RESPONSES TO COMMENTS

UNITED STATES NUCLEAR REGULATORY COMMISSION COMMENTS REGARDING THE DRAFT FINAL SAMPLING AND ANALYSIS PLANS FOR THE REMEDIAL INVESTIGATIONS AT SPRING CREEK PARK AND DEAD HORSE BAY SITES GATEWAY NATIONAL RECREATION AREA, NEW YORK

Final

December 4, 2024

Gamma Radiation Survey
Zscore Results
Grid I-6

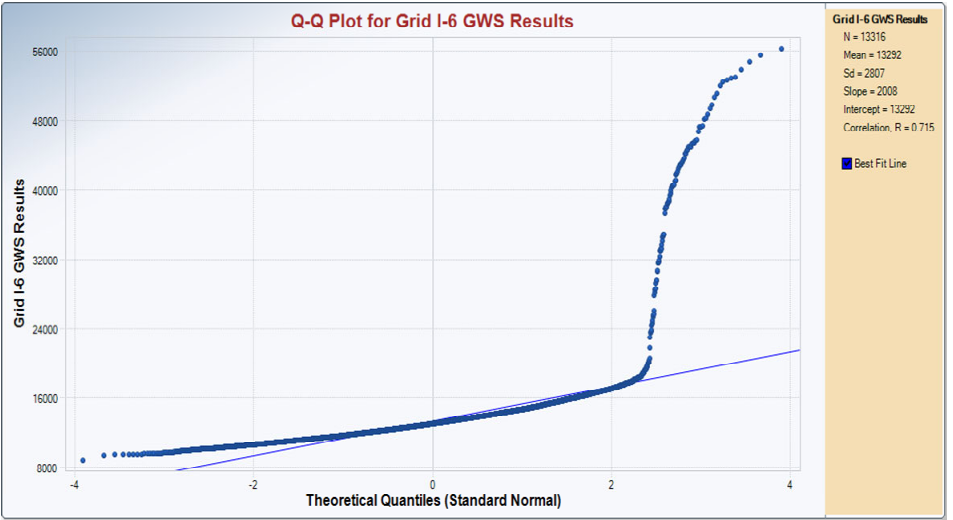
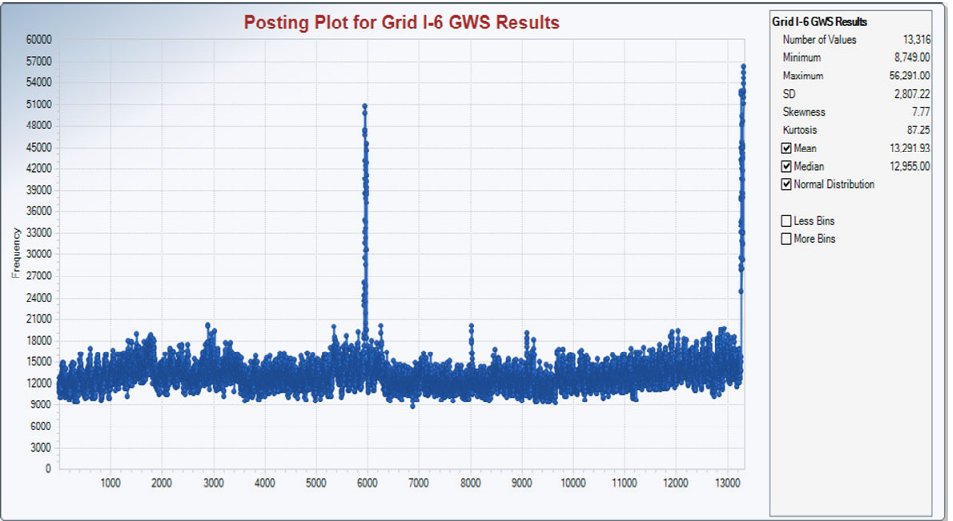
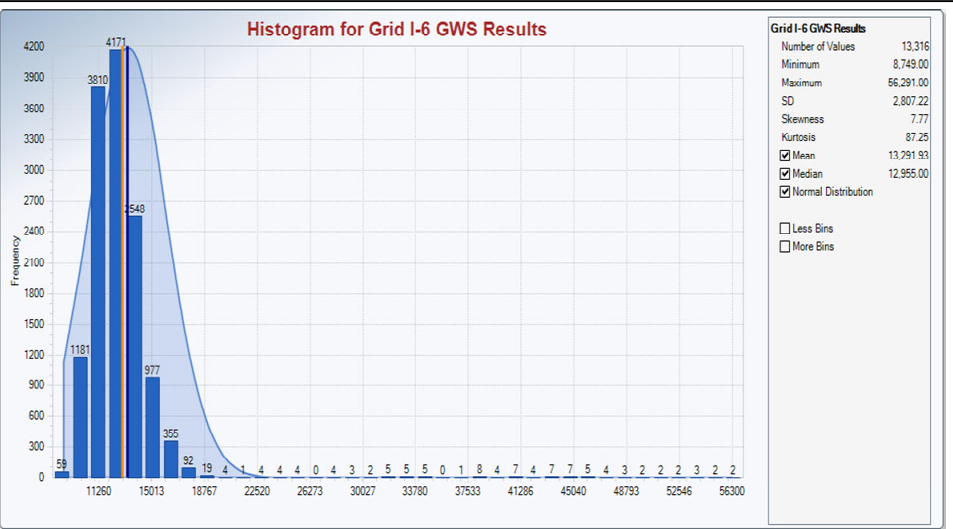
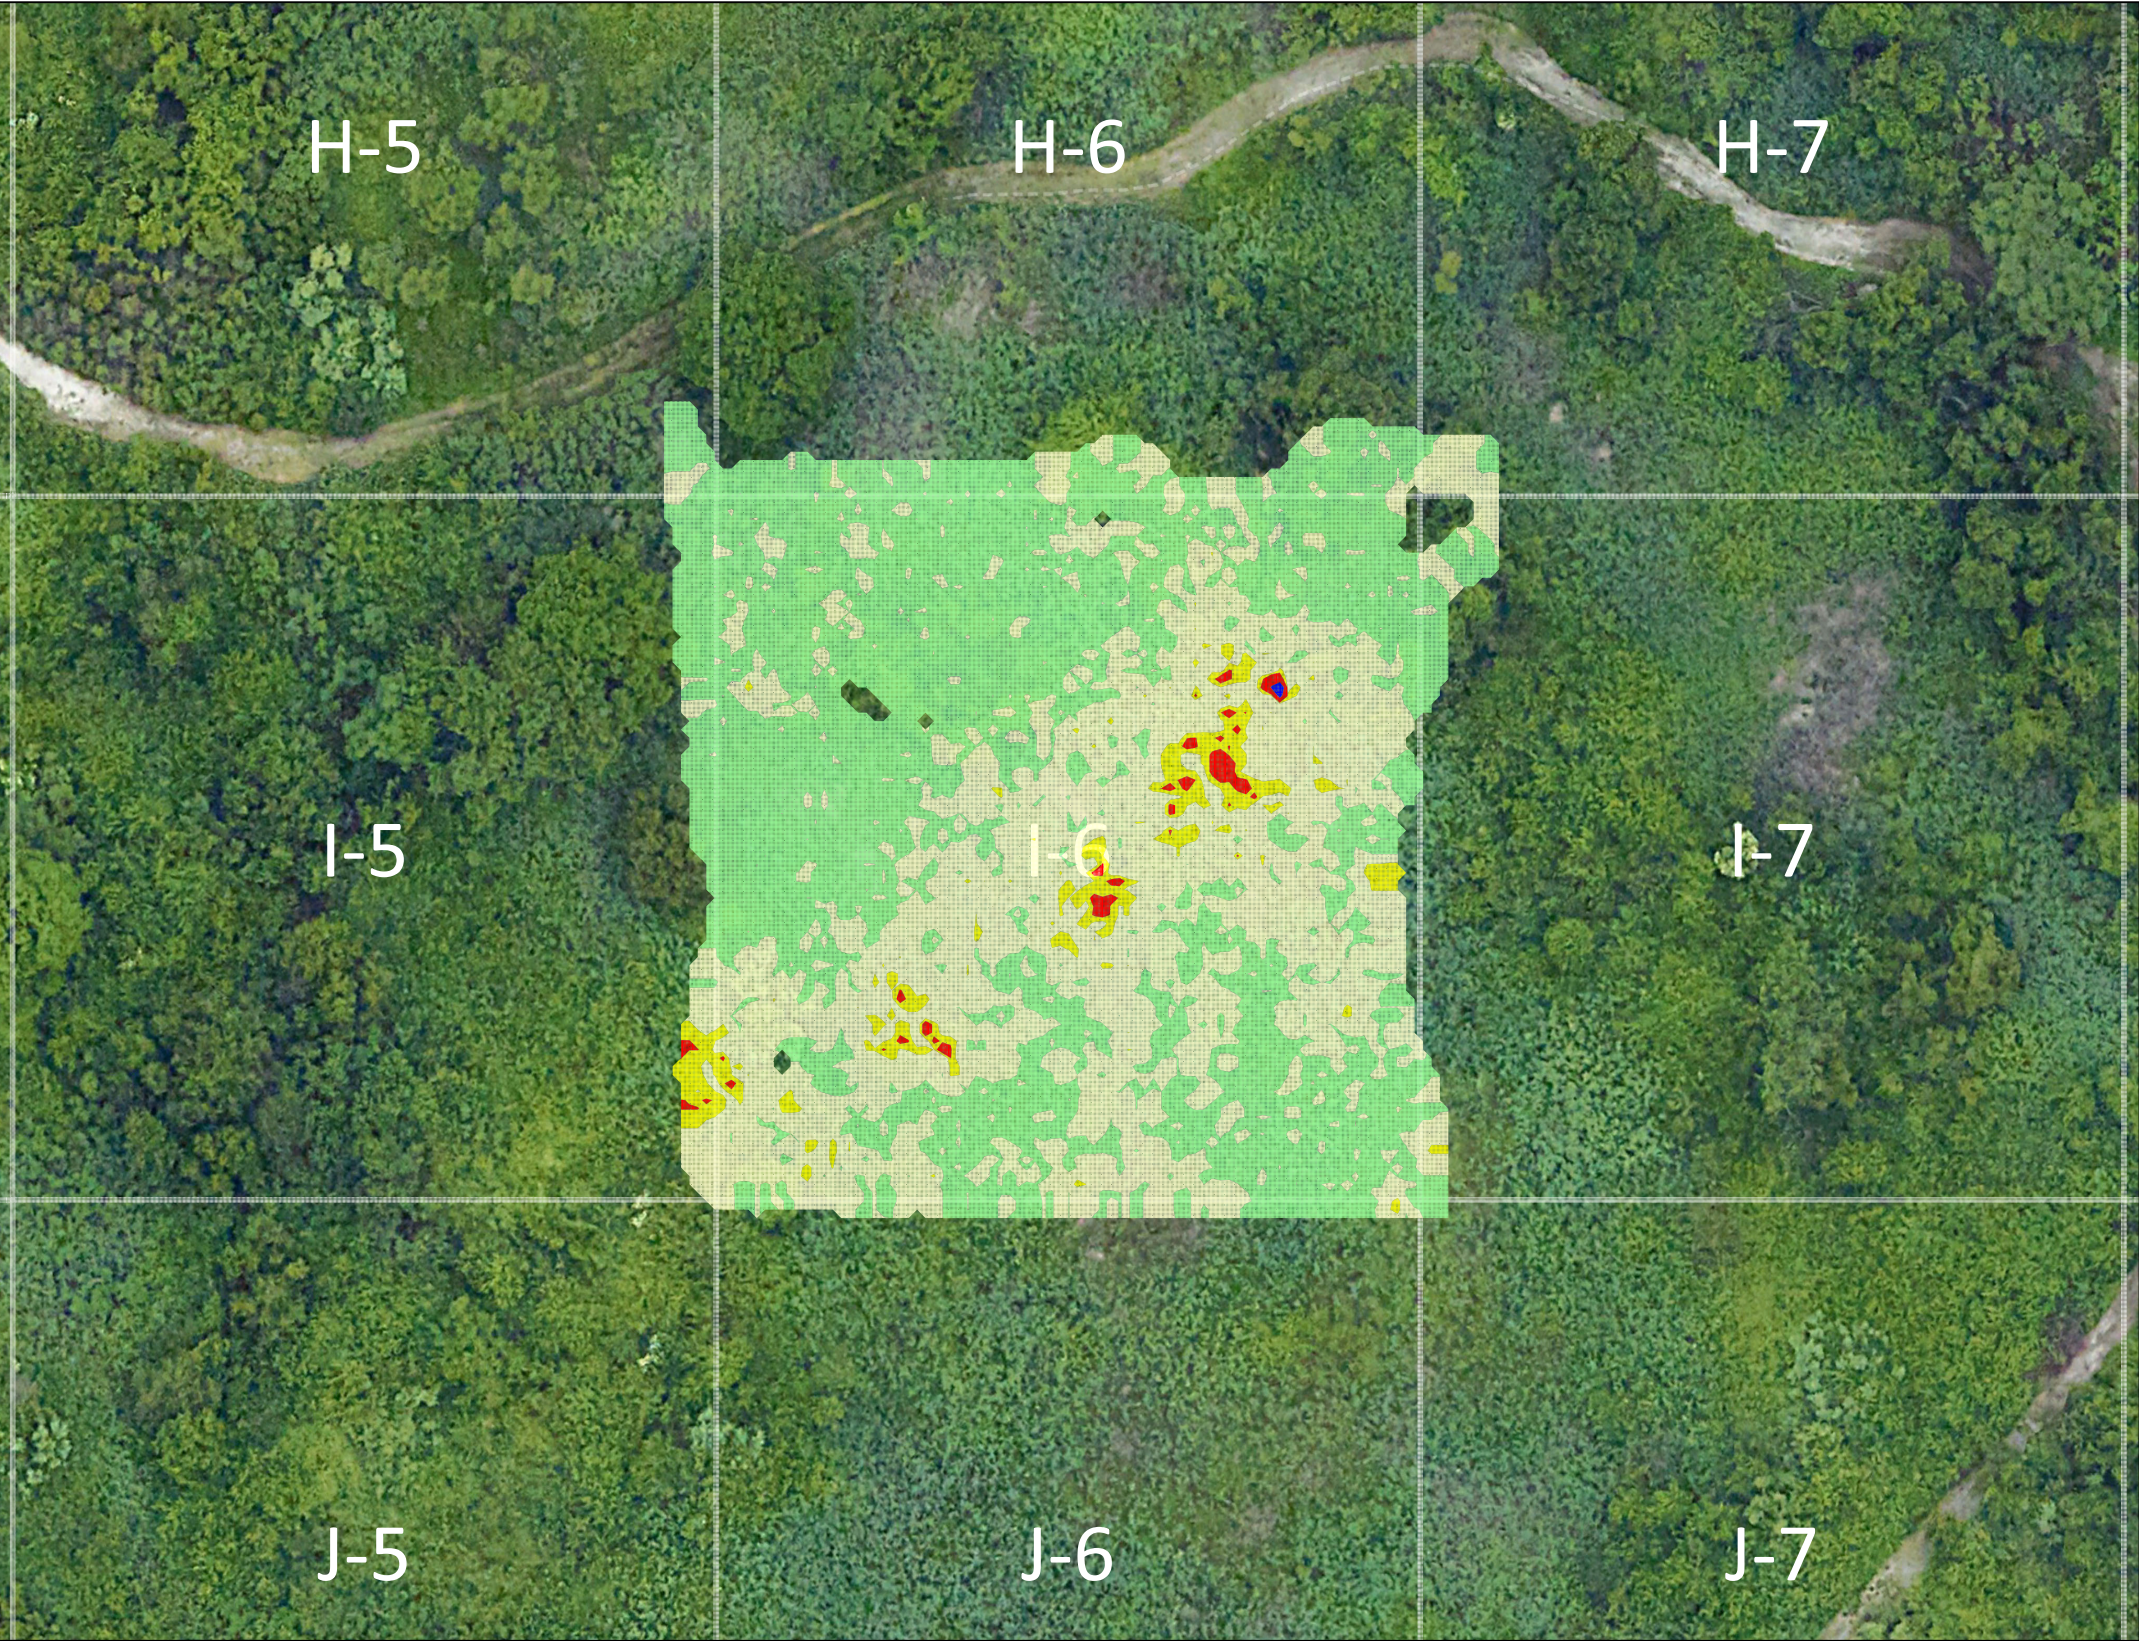
Comment 2: Investigation Level Statistics: The NRC staff recommends that the NPS describe the process for managing data to ensure the calculated z-score value will target the appropriate medium-specific response.

Description: In Section 5.5 of the SCP SAP, NPS states that a z-score greater than three will be considered indicative of contamination. Radiation survey planners often provide an investigation level that, when encountered, will prompt more detailed surveys and/or sampling. The goal is to limit false negative decisions (i.e., to limit the possibility of concluding that a medium is uncontaminated when, in fact, the medium is contaminated). Investigation levels have sometimes been established using historical precedence (i.e., NRC Regulatory Guide 1.86), industry guidance (e.g., per NUREG-1507), somewhat arbitrary guidelines (e.g., twice background), or other methods. The z-score approach is used at some sites, where a z-score is selected to represent a value sufficiently above the mean of the population to warrant additional consideration. For example, for a dataset with a normal distribution, over 99 percent of the results will fall below a measurement corresponding to a z-score = 3. An investigation level corresponding to z-score = 3

NPS Response: NPS understands and agrees with NRC's concerns regarding the Z-score approach described for evaluating gamma survey results and identifying radiological anomalies indicative of potential contamination. The SAPs present the simplest form of the Z-score evaluation in order to convey the general framework that will be used to evaluate the gamma survey data. In practice, NPS implements a more refined and rigorous data processing approach that involves: (1) evaluating gamma survey results in population subsets that are generally one acre in size or less to address the potential for variability in site media, (2) conducting statistical evaluations of each data subset using USEPA's ProUCL software (i.e., descriptive statistics to include evaluations of the kurtosis and skewness of the data subset, time-series data plots, quantile-quantile plots, and histograms) to ensure the subset population is appropriate for identifying contamination using a Z-score evaluation, (3) performing an iterative or modified Z-score approach to address high outliers (if necessary) that may bias the Z-score evaluation in a manner that could result in false negatives, and (4) mapping the resulting gamma survey data based on class-posted count rates, class-posted Z-scores, and contoured Z-scores to clearly map radiological anomalies using multiple approaches to ensure hotspots are not missed. **Attachment 2** presents figures of example data subsets from DHB to demonstrate how the gamma survey data were evaluated. NPS prefers to maintain the SAP in its current form in order to provide an appropriate amount of flexibility for evaluating the gamma survey results.
